Mealstream EC501 (Series 5) CTM3 208V, 60Hz
FCC ID: PCVCTM3206015A
FCC Class II Permissible Change

Description of changes

Heater Control Circuit Proposal

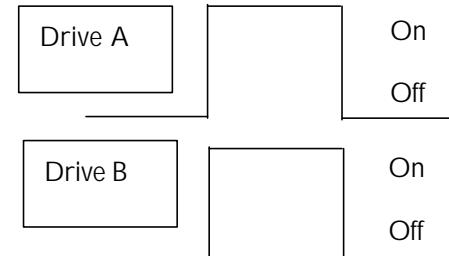
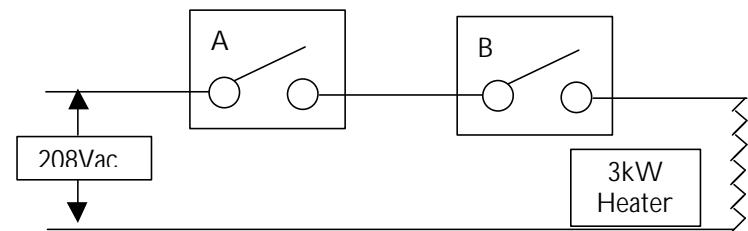
5. Inclusion of Opto-Triac (30Z1189) within the heater control circuitry.

Refer to the block diagram at the end of this document.

A Semiconductor Triac device has been added in the heater control circuitry. Before the modification, the convection heater element was controlled by two series connected relay contacts. The two relay contacts were operated sequentially but could be switched whilst current is flowing.

The modified circuit uses a Triac, which performs the function of zero crossing detection. This allows sequential switching of the relay contacts such that there is minimum current flowing when the relay switch contacts change over.

The control logic to drive the Triac is isolated from the mains switching voltages by means of an opto-isolated triac linked to the switching triac.

A thermal sensor switch is thermally bonded to the Mains switching Triac of the modified heater control circuitry. Should the mains switching Triac overheat, the thermal sensor will trip and cause the heater element to switch off.

The Relay Control Printed circuit board has been modified from Merrychef Part No. 49C0734 to 40C1104. The modified PCB includes the changes associated with the heater control circuit. That is, the opto-triac, Triac, Thermal sensor switch and additional logic gates have been added.
